## BendPak Technical Service Bulletin

### 12AP-SRT Cable and Hydraulic Fitting Substitution

#### BendPak TSB 148-102024

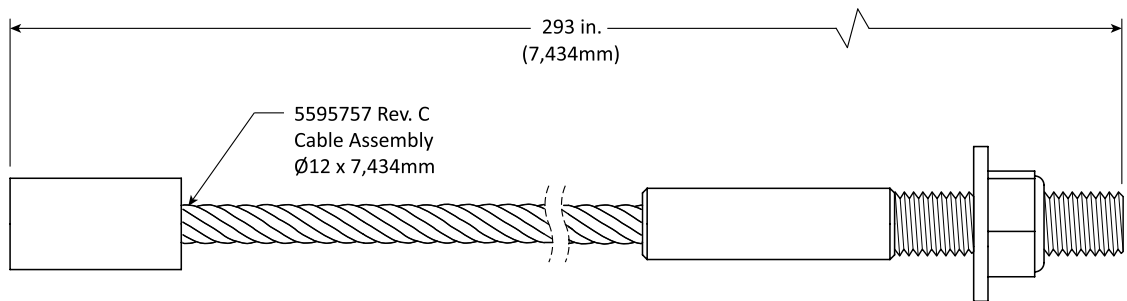
- a. Two Equalizing Cable Assemblies 5595757 Rev. B are included in the 12AP-SRT Parts Box. Remove and discard these two cables, they are undersize.

- b. Retrieve the two replacement Equalizing Cables packaged separately 5595757 Rev. C Cable Assemblies (Ø12 x 7434mm ST). These two longer cables will replace the cables discarded in step 1a above. Refer to the figure above. All Equalizing Cable references in the Installation and Operation Manual will refer to the longer cables described in this TSB.
- c. Replace the table on pg. 23 with the table below.

Lift Model	Part Number	Description
10AP-SRT	5595911	Cable Assembly Ø10 x 7,270 mm
12AP-SRT	5595757 Rev. C	Cable Assembly Ø12 x 7,434 mm
